Toddington Farm

Transport Response to West Sussex County Council

1. A number of comments have been raised relating to transport issues by West Sussex County Council (WSCC) for the Toddington Farm redevelopment project (planning application reference: LU/17/162). This note provides further information and clarification in response to these comments.

Swept path analysis of 10.5m refuse vehicle
accessing and egressing site

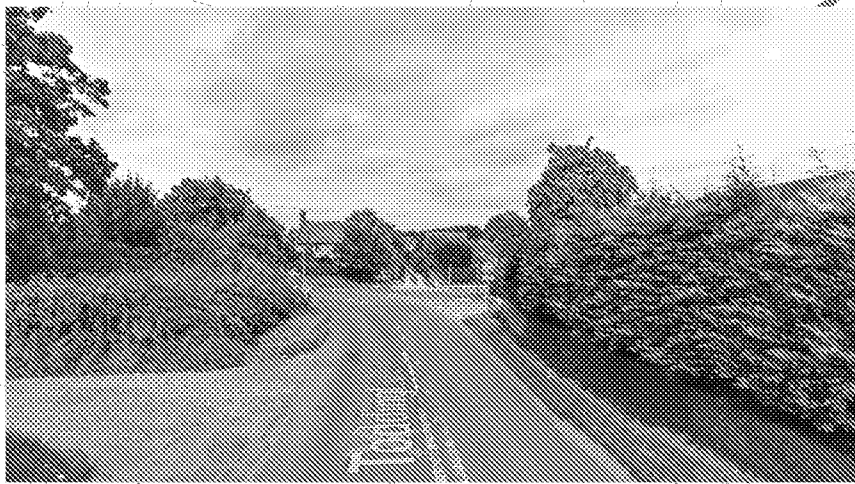
3. *While a swept-path diagram is provided showing the manoeuvre of a service vehicle within the site, the problem raised in the RSA recommends that such vehicles will be able to manoeuvre to and from the development access safely. As such, a further swept-path diagram should be provided for the vehicular access where it meets Toddington Lane.*

- A swept path (drawing 30917/AC/001B) illustrating service vehicles accessing and egressing from the vehicular access on Toddington Lane is provided as part of this document.
